**MINUTES OF REVIEW MEETING ON 3<sup>RD</sup> DELIVERABLE OF 'HYDRO-METEOROLOGICAL RESILIENT ACTION PLAN (HmRAP)' HELD ON 10.08.2021 AT 11:00 AM THROUGH VC IN OPS ROOM, NDMA BHAWAN, NEW DELHI.**

**Observation on Deliverable-3 (HmRAP)**

### Misleading DTM submitted on portal 2

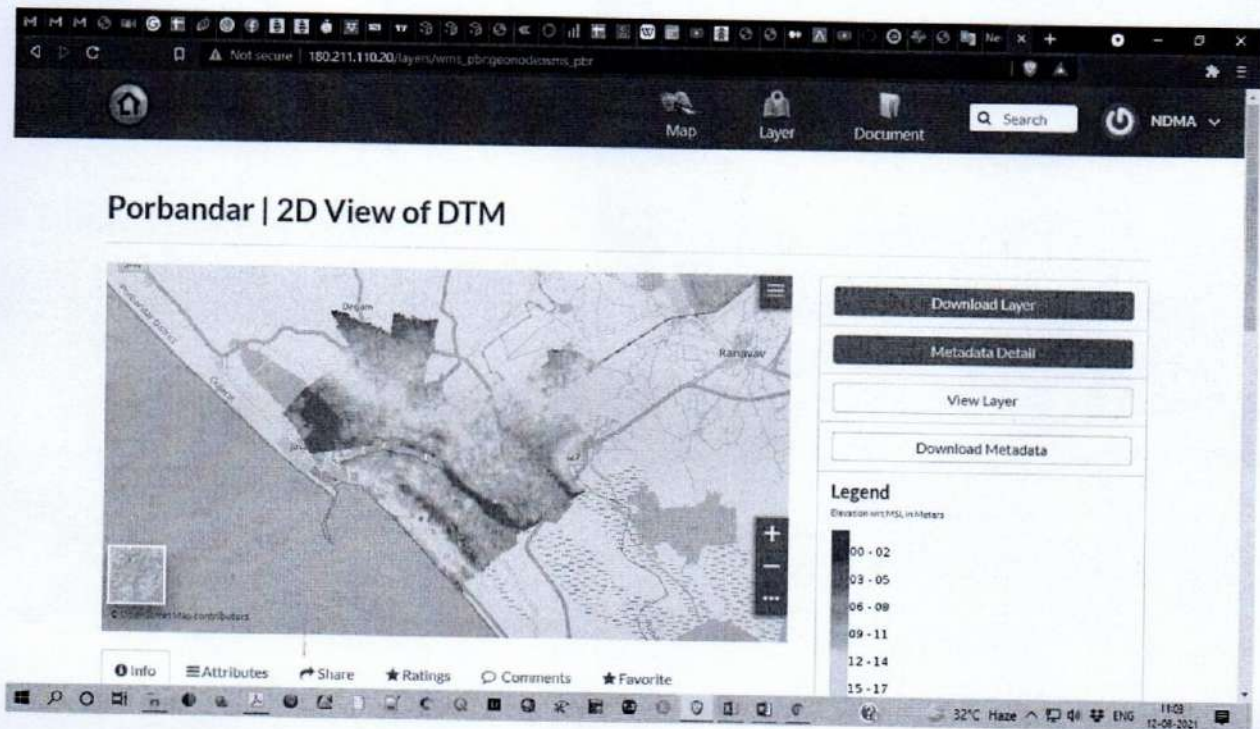
1. The deliverables as per contract are creation of Digital Elevation Model (DEM) and Digital Terrain Model (DTM) for 6 cities. However, the Consultant has submitted only DEMs of 6 cities. When asked for the DTMs of the 6 cities, the information provided in the portal as well as on the digital copies available with the representatives of the Consultant, DTM were absent. The Consultant has included some files under the heading DTM on the portal. However, they are mere random files and do not constitute the requirement of DTM. So the submission deemed to be incomplete.

## Duplicate points from City of Mangalore

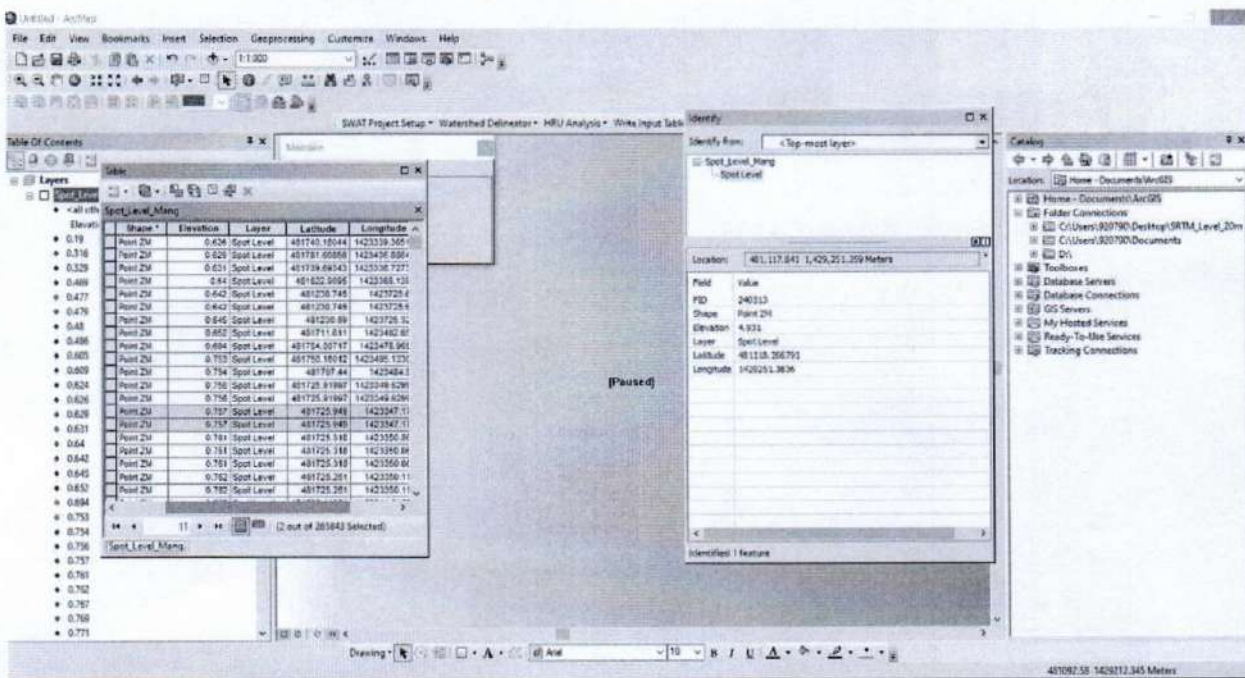
the case of Mangalore, that 14.34% (38127 points out of 265843) of points are duplicated to increase the number of points, which was shown as the density of the points in each city. This may be considered as lack of seriousness and professionalism on the part of Consultant. In case of Ratnagiri, more than 5% (676 points out of 13019) of the data points are duplicated deliberately. In the case of Kochi, 7.4% (65644 points out of 886202) have been duplicated deliberately. Similarly in Porbandar, 2.35% (1308 points out of 55496) were duplicated deliberately. In the case of Bidhannagar, 1.2% (269 points out of 21245) points are duplicated. In the case of Panaji, 2.69% (646 points out of 23933) are duplicated deliberately. The summary is presented in the following table.

## Discrepancy in accuracy of GCP decimal points – Bidhannagar

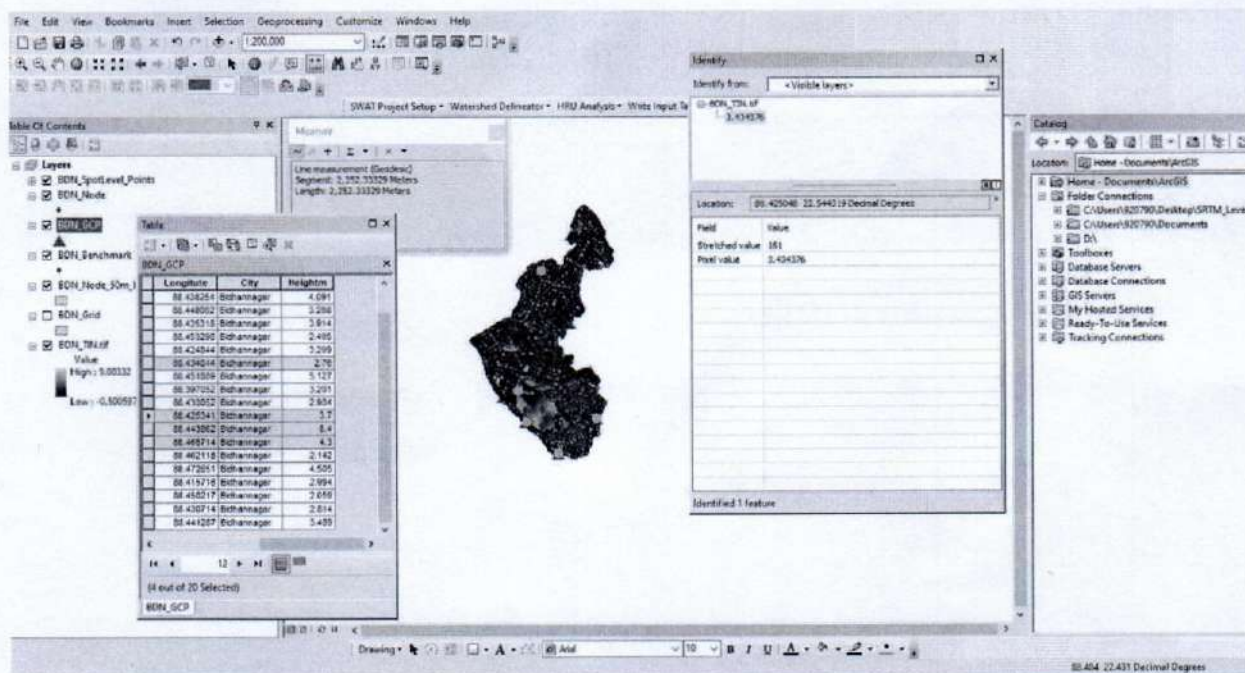
- c) For Bidhannagar city, 5 points out of 57 have deviation more than allowed limit. The deviation was 8.7% whereas the allowed deviation is 5%.
    - d) It was observed that the Consultant manipulated the survey points deliberately to show more number of points collected, than the actual survey. It is observed, in
